## SAN LORENZO VALLEY WATER DISTRICT

August 7, 2015

California Department of Water Resources Attn: Sustainable Groundwater Management Section P.O. Box 942836 Sacramento, CA 94236

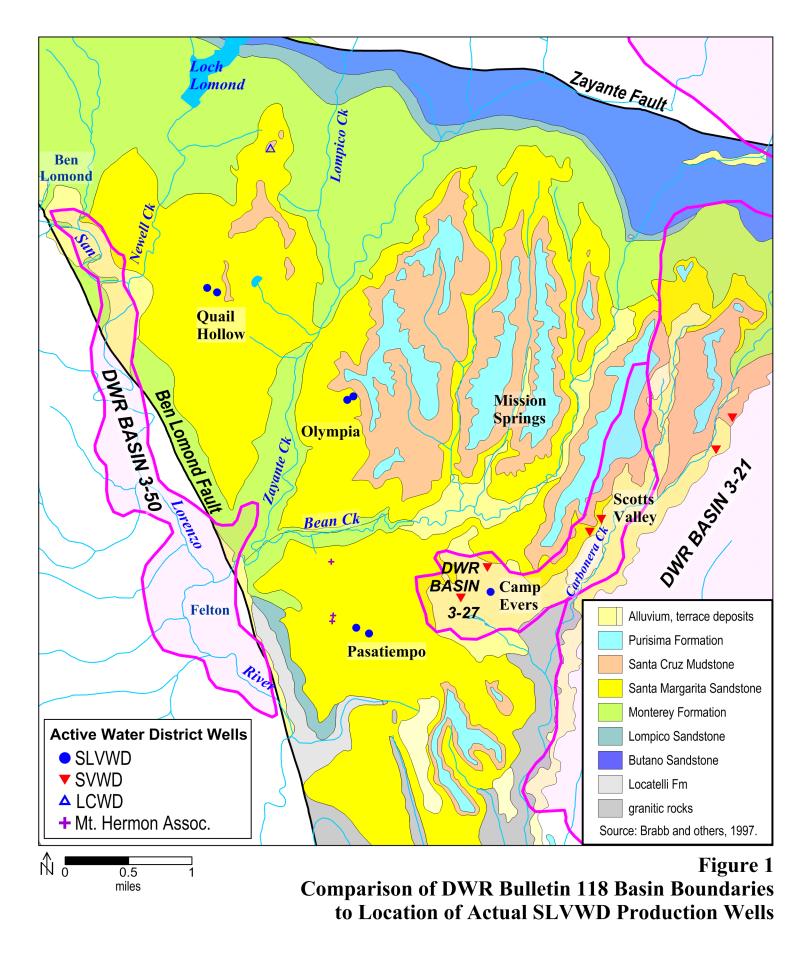
Within the boundaries of the San Lorenzo Valley and Scotts Valley water districts, DWR's Bulletin 118 update defined the Felton basin (no. 3-50) as a relatively small area of exposed alluvial deposits along the San Lorenzo River where no wells exist, and the Scotts Valley basin (no. 3-27) as a relatively small area of thin alluvial deposits in Camp Evers. These designations do not encompass the actual sandstone aquifers upon which the local communities rely (Fig. 1 attached).

Figure 2 Schematic Geologic Cross Section of SLVWD Groundwater Source Areas

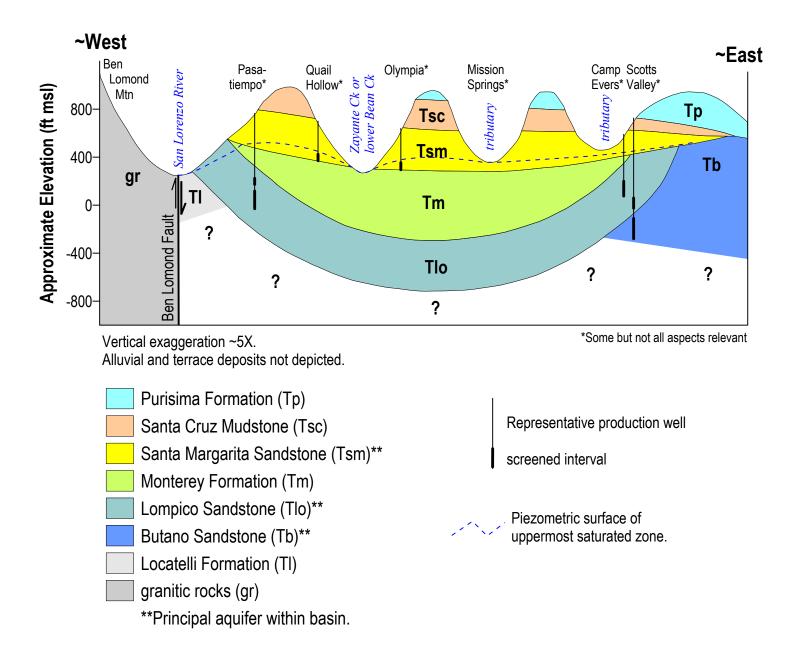
We at the San Lorenzo Valley Water District would like to make California's 2014 Groundwater Sustainability Act work for us, beginning with a more accurate recognition of our actual groundwater basins (Fig. 2 attached). Please provide clarification that a basin can consist of permeable sandstone formations, such as the Santa Margarita and Lompico Sandstones. And please confirm that DWR will be responsive to our attempts to comply with the 2014 Act by revising our basin boundaries and submitting a Groundwater Sustainability Plan that will address critical local overdraft issues.
